# PacifiCorp - Stakeholder Feedback Form

## 2023 Integrated Resource Plan

\*Organization: Utah Clean Energy

**Figure 1.8 – 2021 IRP Preferred Portfolio Energy Efficiency and Demand Response Capacity**

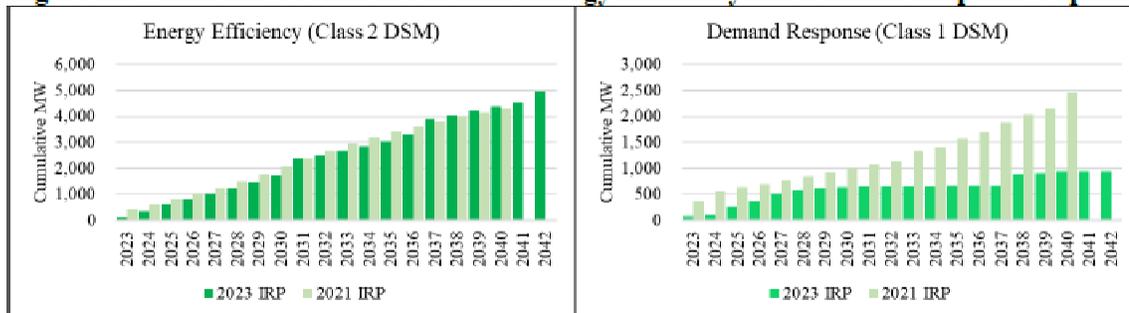
3. Please confirm that Figure 1.8 shows a comparison of the 2021 IRP Preferred Portfolio with the 2023 IRP Preferred Portfolio for Energy Efficiency and Demand Response Cumulative Capacity.

4. The model’s Class 2 DSM selections (see chart below) do not represent how energy efficiency resources can be implemented and procured. While the 20-year 2023 IRP projection for DSM is higher than in the 2021 IRP

(see Figure 1.8), the uptake of DSM lags that projected in the 2021 IRP until 2031, when it suddenly catches up. Then it lags again until 2037, when the 2023 DSM projection finally exceeds the 2021 projection. The model clearly shows that Class 2 DSM is an economic resource, selecting approximately 2% of load by 2031.

Confirmed.

Answer: The model optimizes around the economics in a given year and may not reflect how energy efficiency portfolios change or evolve over time. In action planning and target setting, programs may develop targets that accelerate adoption where appropriate to avoid volatility in delivery and rate impacts.

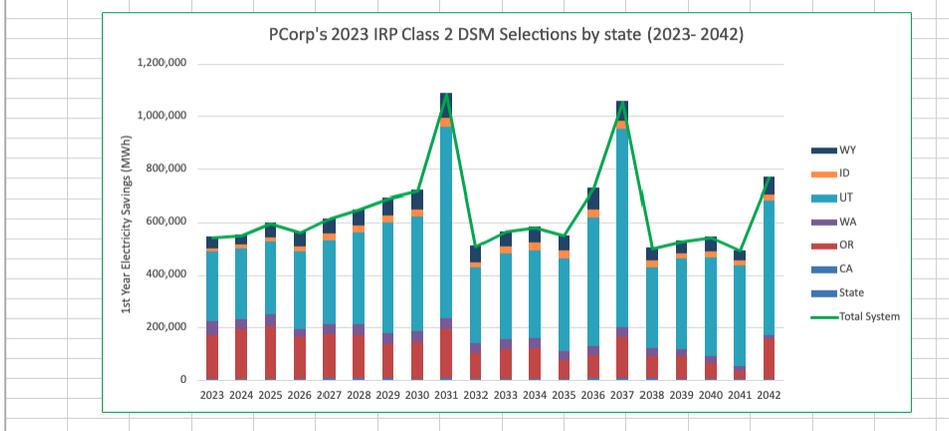
Given that there are many uncertainties with respect to supply-side resources in the later years of the draft Plan, DSM provides a cost-effective hedge against potential procurement delays associated with these resources. The Action Plan should include strategies to build cost-effective Class 2 resources to meet 2% of load by 2031. Given that the IRP selects this level of Class 2 DSM for 2031 and 2037, these resources should be acquired and maintained throughout the IRP timeline. ***UCE recommends a consistent ramp rate with the goal of achieving Class 2 DSM resources equal to 2% of load by 2031.***

Answer: DSM is selected on a cost-effectiveness basis and that selection is not constrained by a proportion of load but rather the economics in each year and state. A 2% of load target does not reflect the cost or benefits associated with differing amounts of energy efficiency or specific measures that might bring more or less net benefits in comparison to other resources in IRP modeling.

**Figure 1.8 – 2021 IRP Preferred Portfolio Energy Efficiency and Demand Response Capacity**

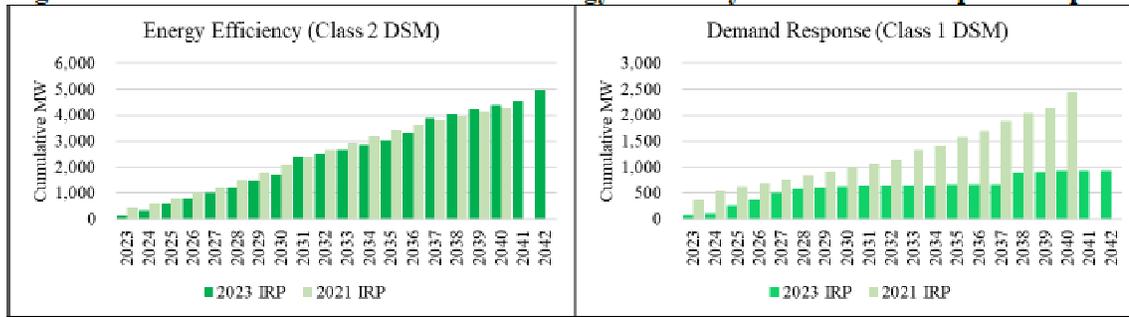
1. The modeled DR resource allocations are highly variable and are significantly below the 2021 IRP DR allocation. *See infra* and Figure 1.8. This is despite the fact that the draft IRP projects a large increase in private generation from solar (3.18 MW) and a corresponding increase in private generation battery storage, both of which include notable projected DR benefits. The year-by-year variability of DR chosen by the IRP is not reflective of DR program growth, and maintenance and increased program uptake should be managed intentionally to reflect the ongoing value and reliability of this resource with more stable implementation during the planning period. ***Given that the 2023 IRP calls for 113.2 MW of new DR by 2038, we recommend that the Action Plan be modified to call for a consistent year-by-year increase in DR starting in 2024 to achieve 113.2 MW of DR in 2038.***

Answer: As with any other competing resources, if additional cost-effective demand response resources become available, the Company will seek procurement regardless of whether the resource was in our forecast. The action plan focuses on near-term acquisition, and if additional demand response is acquired through participation in current demand response offerings, the Company will procure it. The Company will continually assess its position relative to IRP volumes and determine if an acceleration of acquisition is needed for a more consistent ramp.

**Figure 9.24 - Increase/(Decrease) in Proxy Resources when all DSM programs are selected in P-MM Variant (P13-All DSM)**

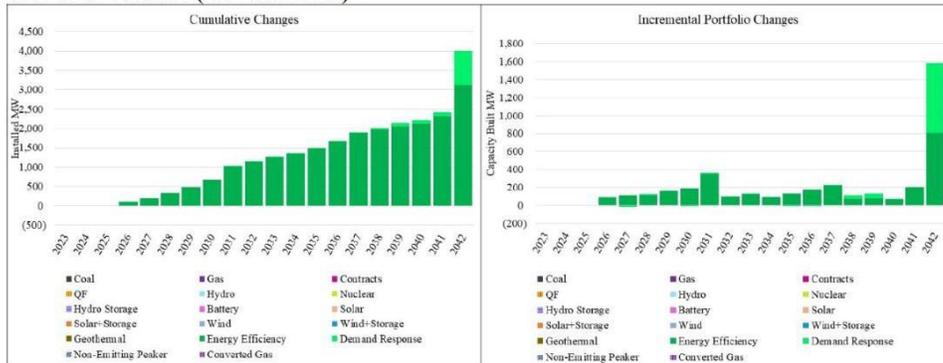
In Chapter 9, model variant P13-All DSM “forces the model to select all demand response and energy efficiency available in addition to what is selected in the PMM portfolio.” However, a cursory glance at the model results (pasted below) raises red flags, especially the lack of DSM throughout the model run until the very last year, and then the very large increase in energy efficiency and DSM in the year 2042. This is further evidence that the DSM part of the PLEXOS model is not working as expected and is producing anomalous results. This variant is also one of the most expensive ones, as indicated in Table 9.13.

**Given all of the issues identified in our comments above about the DSM modeling, we do not think that the P13-All DSM model variant is accurate. Once the issues identified above have been addressed, this model variant should be re-run.**

Answer: These charts represent the change in the portfolio for the Preferred Portfolio versus P13-All DSM Variants. Furthermore, the chart on the left (cumulative changes) does not align with your assertion that there is a “lack of DSM throughout the model run.” As stated previously, this variant is intended to be a bookend to illustrate the cost that might be incurred if the maximum DSM potential were selected.
